To: Spierian Fall Protection End-Users
From: Spierian Fall Protection
Date: 11/04/2010
Subject: Recall Notice (*Immediate Attention Required*)

PENSAFE™
STRENGTH & SECURITY
RECALL NOTICE
3730 Anchorage Connector

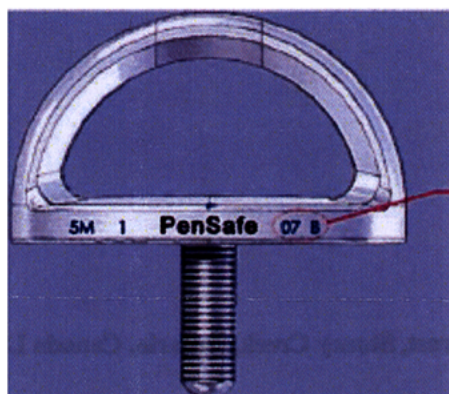
We have identified an issue with a batch of 3730 Anchorage Connectors manufactured in the latter part of 2007 and distributed by PenSafe Inc. from June 2008 through June 2009. We have examined a part as part of a root cause analysis which exhibits a heat treatment deficiency. The result is a potential embrittlement on anchorage connectors with the 07 B year and heat code. This embrittlement may cause the threads on the stem to fracture prematurely from the stress created by the torque of the nut during installation. Note that this may not be evident at the time of installation and the fracture may develop over time.

In order to find and remove the defective parts from use, PenSafe is issuing this recall for all 3730 anchorage connectors with manufacturing code "07 B". The diagram below identifies the location of this manufacturing code for positive identification of the suspect product. It will appear to the right of the PenSafe name.

In response to this issue PenSafe has implemented a corrective action change in the approach to the proof loading of the 3730. The threaded portion is now mounted in a plate and subjected to proof load in conjunction with the load on the ring. Should you have additional questions or concerns with regard to this issue, please contact PenSafe directly at 1-866-212-2211, and ask for Bob Claus at extension 233, or Keith Smith at extension 243.
